35/32-92A 5315 Elliot Drive
Battery Bailey

RE: Battery Bailey Restoration Plans

APPLICATION FOR HISTORIC AREA WORK PERMIT

Fig. 5.

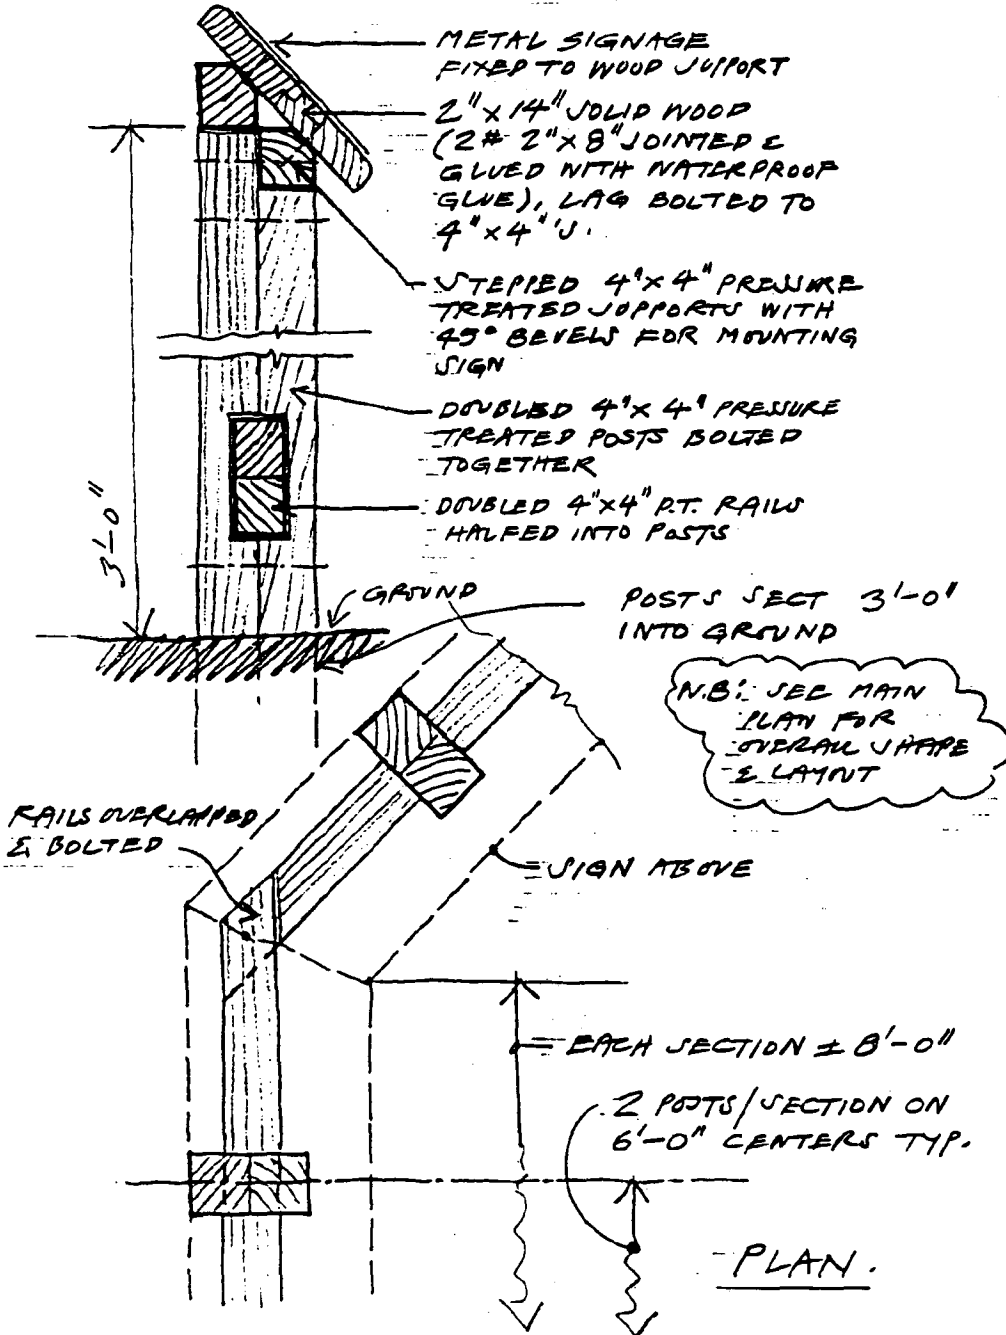
The staff questions the size of the platform, which is designed for groups of 20 people. The earthworks should be left as clear of man-made elements as possible, especially in a prominent position overlooking the site.
